APPLICATION NO.	FILING DATE	FIRST NAMED INVENTOR	ATTORNEY DOCKET NO.	CONFIRMATION NO.
10/562,166	06/05/2006	Volker Krisch	5488-6	7662
22442 SHERIDAN RO	7590 09/02/200 DSS PC	EXAMINER		
1560 BROADWAY			MERLINO, ALYSON MARIE	
	SUITE 1200 DENVER, CO 80202		ART UNIT	PAPER NUMBER
·			3673	
			MAIL DATE	DELIVERY MODE
			09/02/2009	PAPER

Application No.	Applicant(s)
	10/562,166	KRISCH ET AL.
Office Action Summary	Examiner	Art Unit
	ALYSON M. MERLINO	3673
The MAILING DATE of this communic Period for Reply	cation appears on the cover sheet wit	h the correspondence address
A SHORTENED STATUTORY PERIOD FOWHICHEVER IS LONGER, FROM THE MA - Extensions of time may be available under the provisions of after SIX (6) MONTHS from the mailing date of this commulation. - If NO period for reply is specified above, the maximum state. - Failure to reply within the set or extended period for reply within the	ALLING DATE OF THIS COMMUNIC f 37 CFR 1.136(a). In no event, however, may a re nication. utory period will apply and will expire SIX (6) MON' rill, by statute, cause the application to become AB.	CATION. Poply be timely filed THS from the mailing date of this communication. ANDONED (35 U.S.C. § 133).

FIG.4

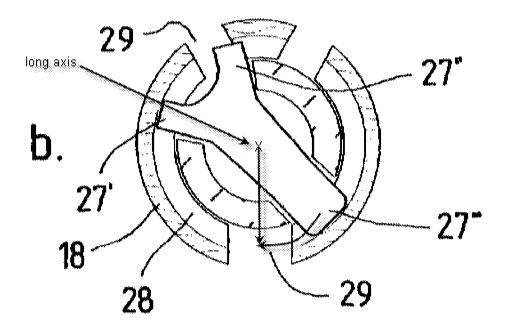
at least one of which includes a lock core 14, which can be operated by a key (apparent from Figure 1) that is mounted to rotate, in which the lock core cooperates with the lock tab 17, 18, which operates, in particular, a bolt or latch of a door lock (Paragraph 26), and with a fitting key (Paragraph 25), an electromechanically driven blocking or coupling element (Figure 4b) is moved from a rest position (Figure 2) to an operating position and produces a splined connected between the key and the lock tab (Figure 5b), whereas the lock tab, in the rest position of the blocking or coupling element, is freely rotatable (apparent that there is no connection in Figure 2) relative to the lock core, wherein the blocking or coupling element is arranged on the lock (apparent from Figure 1) and rotates with it (apparent from Figures 2 and 5, rotates when coupled together), and includes an eccentric 26 that is rotatable between a first (Figure 4b) and second (Figure 5b) position such that when the eccentric is in the first position, a driver 27" in communication therewith is in a rest position (apparent from Figure 4b), and when the eccentric is rotated from the first position to the second position, the driver is moved in a direction substantially perpendicular to a long axis (see figure below) of the lock core into an operating position (see figure below) in which the driver engages in a recess 29 of the lock tab.
